Rear axle bush for wheel bearing housing

febi no. 21174

OE No. 204 352 00 27

**Mercedes-Benz C Class (202, 203 and 204),
E Class (207, 211 and 212), S Class (221) and other models**

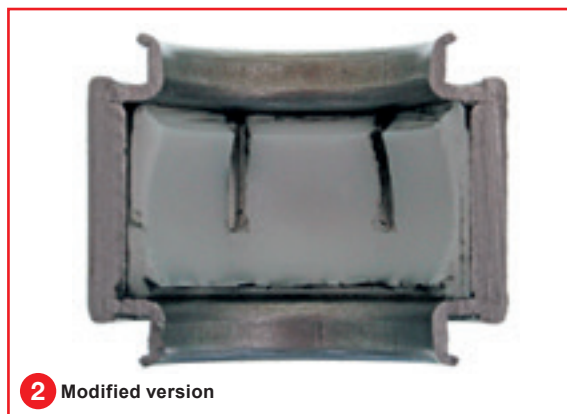
Knocking or creaking noises can occur in the region of the rear axle when driving.

Due to its design, the life of the rear axle bush is shortened by poor road and weather conditions. The version originally fitted (Repl. no. 201 352 00 27) has a lubrication channel in the inner plastic tray (see Fig. 1). However, this is not always sufficient to lubricate the joint evenly. The drying out that is sometimes associated with this makes the joint susceptible to wear. Mercedes-Benz has withdrawn this version from service and replaced it.

febi bilstein recommends using the new version of the joint febi 21174 (Repl. no. 204 352 00 27). The modified joint has several channels instead of just one (see Fig. 2). This ensures a permanent supply of grease which lengthens the joint's lifetime.
